**INDEPENDENT REVIEW  
OF THE SLUDGE SOLIDIFICATION WASTE TREATMENT PROCESS  
FOR THE TRU WASTE PROCESSING CENTER  
AT THE OAK RIDGE RESERVATION**

August 14, 2007

Prepared by  
Pro2Serve<sup>®</sup> Professional Project Services, Inc.  
Oak Ridge, TN 37830  
under Contract No. DE-AM05-04OR23073  
Project Order No. DE-AT05-07OR23137.M001

Figure 3. Sludge Drying and Supernate Process

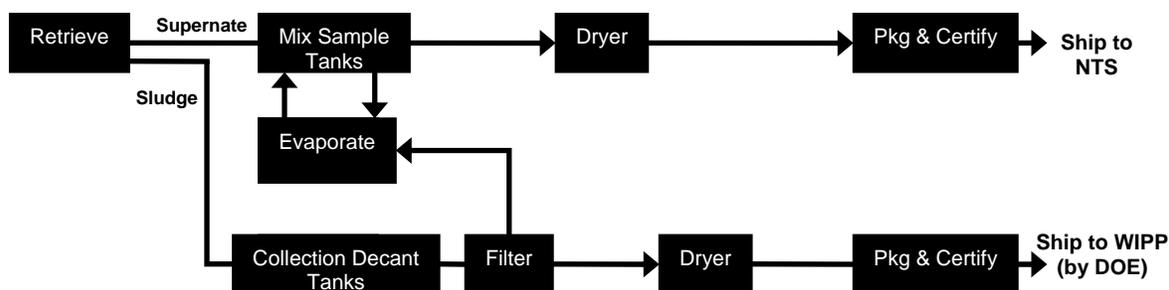
The RH Debris and Sludge Operability Review identified operability issues associated with the dryer during the supernate campaign.

- “Significant build-up on the dryer agitator and dryer wall occurred in both surrogate testing and actual supernate processing.”
- “Reliable powder discharge could not be achieved due to frequent plugging of the SN dryer discharge valve during surrogate testing.”
- “Numerous entries in to the high radiation areas were required for inspection, testing and repair of single point failures/leaks during the nine month campaign.”
- “[Since] crystal formation on sealing surfaces can cause premature component failure/leakage; periodic outages to drain, flush and acid clean the systems were necessary to keep equipment operable.”

- Although the overall dose during supernate operations was very low, 69 mRem/liner shipped, 6.7 mRem/liner shipped “The most dose intensive task during the SN campaign was the seal/cut of the SN [Supernate] liner fill sleeve from the SN [Supernate] dryer discharge chute which included dose related to clean-up of any ensuing contamination of the LLW liner of shipping cask. Contamination spread was occurring when only a single discharge sleeve was used. A second sleeve (double confinement) was incorporated into the process. Even without a powder waste form, contamination control around the final SN [Supernate] waste container interface was a challenge.”

Figure 8. Sludge Solidification Process Overview (Ref. 2)

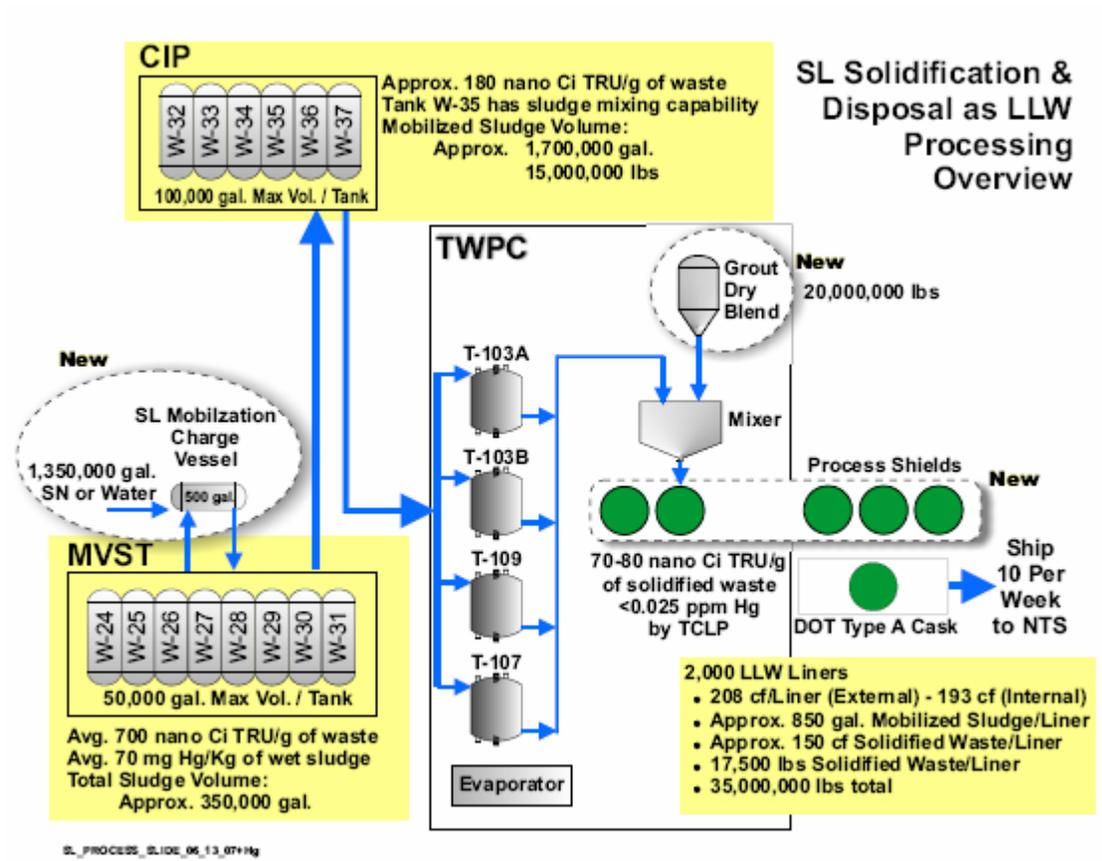
From the draft Feasibility Study (Ref. 2), proposed changes include modifications to:

- The SN [Supernate] dryer, presumably from lessons learned 2, 3, and 4 (above) in the SN [Supernate] campaign. This is discussed in 4.2.3 below.
- The back-up power system, presumably from lessons learned 1, 2, and 6 (above) in the SN [Supernate] campaign and reasonable operational consideration. This recommendation is based on the need to maintain operations for a grout system such that a power outage would not cause system failure due to the grout setting up in the dryer because the power is out. This is appropriate and not evaluated further in this review.

- The 30-ton crane bay, presumably as a result of new operational needs. This is discussed in Section 4.2.5 below.
- The decontamination/system flush, presumably from lessons learned 6 (above). This is appropriate and not evaluated further in this review.

- The acid cleaning system for Batch Mixer, presumably from lessons learned 1 and 2 (above). This is appropriate and not evaluated further in this review.

- The Isolok samplers, presumably from lessons learned 7 (above). This is appropriate and not evaluated further in this review.
